Staff Summary Report

Development Review Commission Date: 05/08/12

SUBJECT: Hold a public meeting for a Development Plan Review for BILL LUKE FIAT, located at 7833 S. Autoplex Loop.

DPR12048 – Development Plan Review including revised site plan, new building elevations, and revised landscape plan.

SITE PLAN SCALE: 1/8" = 1'-0"

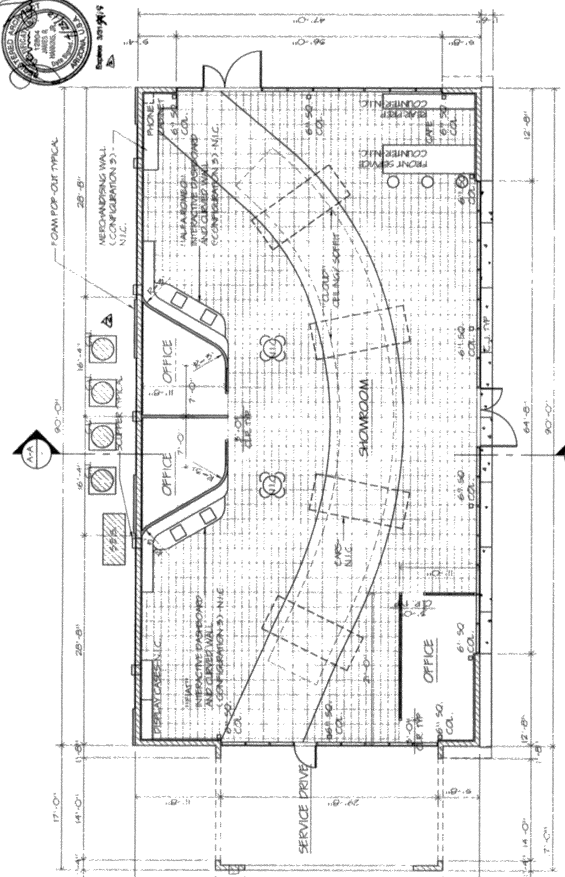
1. HVAC and SES located on the east side of building are to be screened by a CMU wall on the south side (facing street) and secured with wrought iron fence on the north and east sides (facing parking), with landscape outside of the fenced area. Other building equipment not identified on plans must be fully screened on ground or roof.
2. Utility equipment boxes for this development shall be finished in a neutral color (subject to utility provider approval) that compliments the coloring of the buildings.

SECTION
 EXTERIOR ELEVATIONS
 FLOOR PLAN
 JOB NO.
 REVISIONS

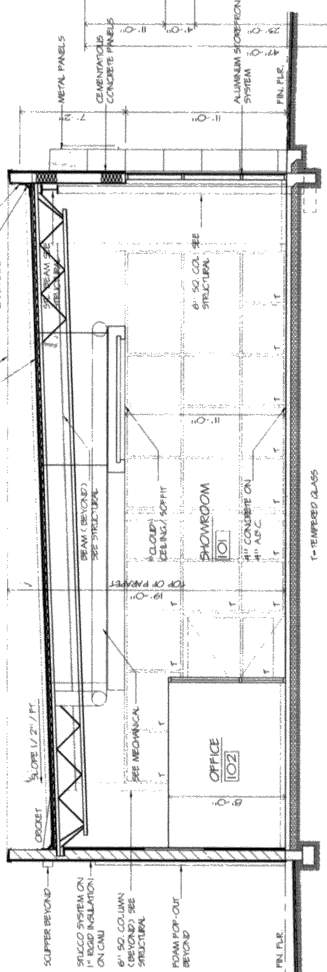
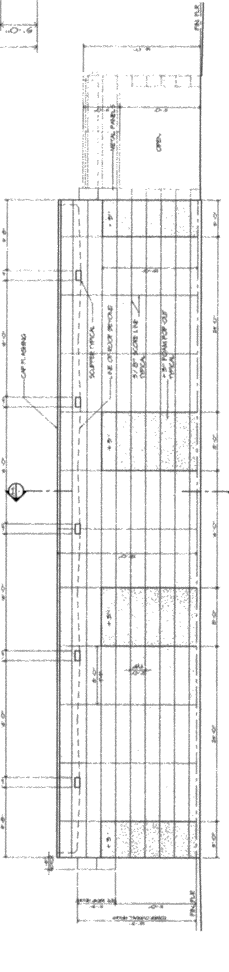
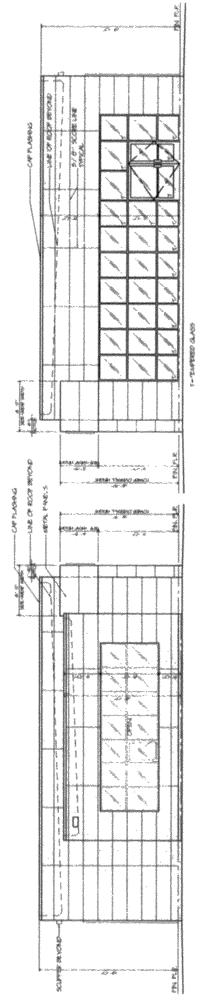
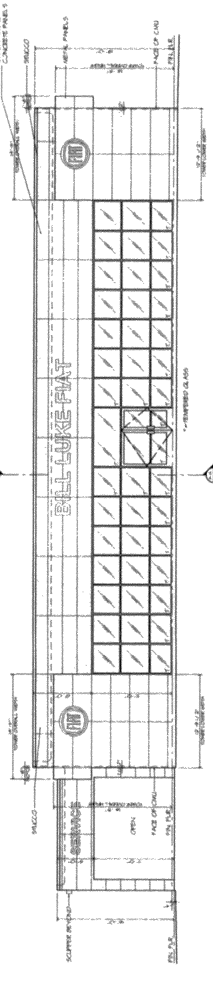
3. The materials and colors are approved as presented:
 Cement Board – American Fiber Cement Corp. Dark Grey E20: 2' x 8' panels 5/16" thick
 Metal Panel – powder coated Bbr Red 4mm thick
 Aluminum storefront system
 Painted Scored Stucco – Sherwin Williams SW6002 LRV 49%
 Provide main colors and materials with a light reflectance value of 75 percent or less. Specific colors and materials exhibited on the materials sample board are approved by planning staff. Additions or modifications may be submitted for review during building plan check process.

4. No roof access required, if plans are modified to require, provide internal ladder access, fully screened at parapet.
5. Minimize visible, external features, such as overflows, and where needed design these to enhance the architecture of the building.

6. If mechanical system requires air intake vents, locate these on the east side of the façade over the HVAC units with an architectural application appropriate to the façade.

7. Incorporate lighting, address signs, and incidental equipment attachments (alarm klaxons, security cameras, etc.) where exposed into the design of the building elevations. Exposed conduit, piping, or related materials is not permitted.
8. Upper/lower divided glazing panels in exterior windows at grade level, where lower glass panes are part of a divided pane glass curtain-wall system, shall be permitted only if laminated glazing at these locations is provided.

PLANTING KEY NOTES

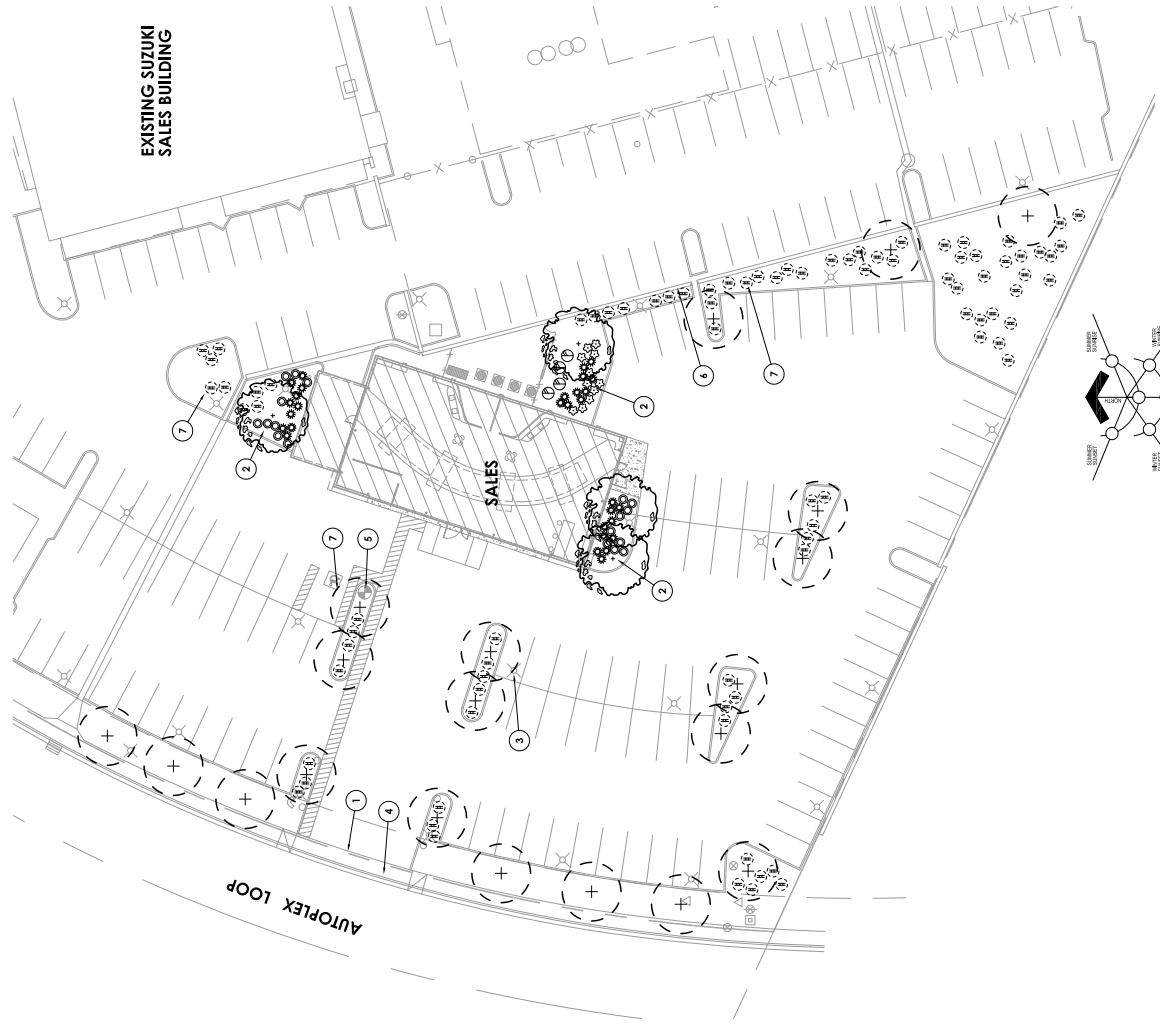
11. The plant palette is approved as proposed and specified on the landscape plan. Evergreen Elm may be substituted for Acacia at the new building location; 15 gallon trees are acceptable as long as 1 ½" caliper trees are provided as required at the end of parking rows (two south of the building and one east of building). Any additions or modifications may be submitted for review during building plan check process.

14. Top dress planting areas with a rock or decomposed granite application. Provide rock or decomposed granite of 2" uniform thickness. Provide pre-emergence weed control application and do not underlay rock or decomposed granite application with plastic.
